Department of Environmental Conservation Division of Spill Prevention & Response

18 AAC Chapter 75 – Oil and Other Hazardous Substances Pollution Control

Proposed Regulation Revisions November 1, 2021

Figure 1: Regional Master Contingency Plan Boundaries (18 AAC 75.495)

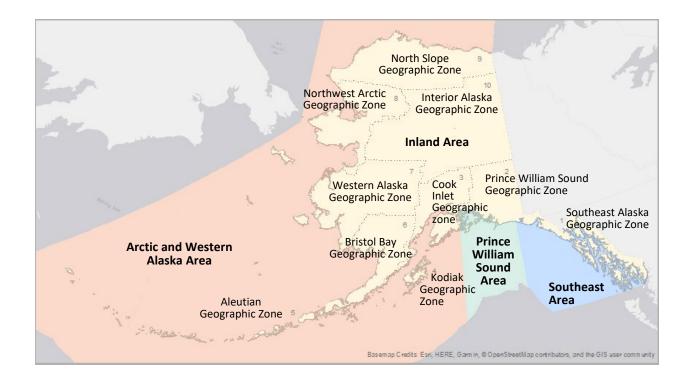
18 AAC 75.495 is amended by updating Figure 1:

Figure 2. Regional Response Operations Plan Boundaries (18 AAC 75.496)

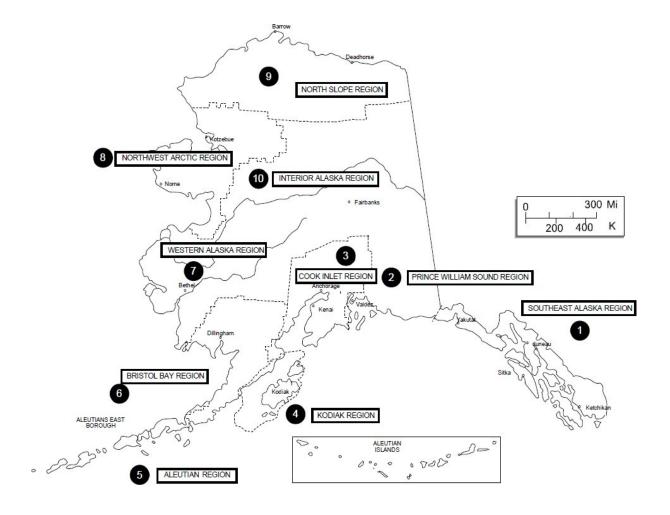
18 AAC 75.496 is amended by updating Figure 2:
